To: Palmyra Village Board
From: Josh Meyerhofer, MSA
Subject: Westfield (Marsh Road) PUD – Subdivision Plat, Preliminary Plat
Date: October 31, 2025

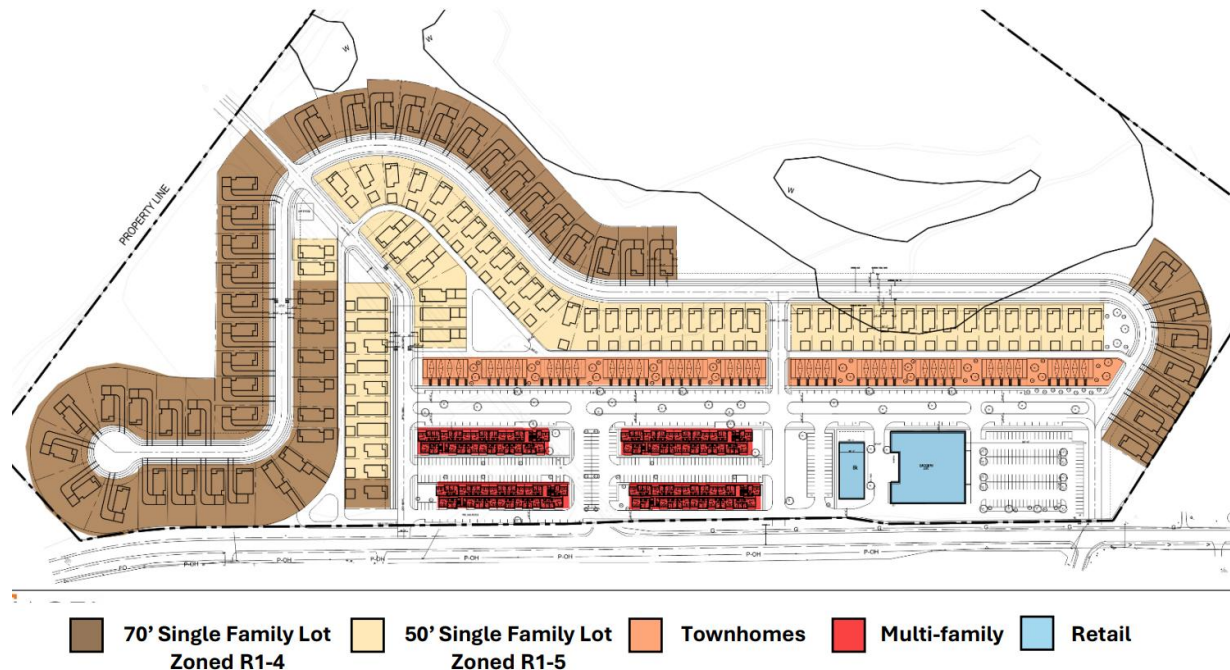
A Planned Unit Development is an overlay district that relies on the underlying district zoning standards and applies exemptions for them based on development trade-offs. The proposed zoning as outlined on the Westfield (Marsh Rd) Planned Unit Development designates properties within the following zoning districts:

- R1-4 (Single Family Lot)
- R1-5 (Traditional Single Family Lot)
- R2-6 (Plex Residential/Townhome Lot)
- R3-12 (Multi-Family Lot)
- B-2 (General Business/Retail)
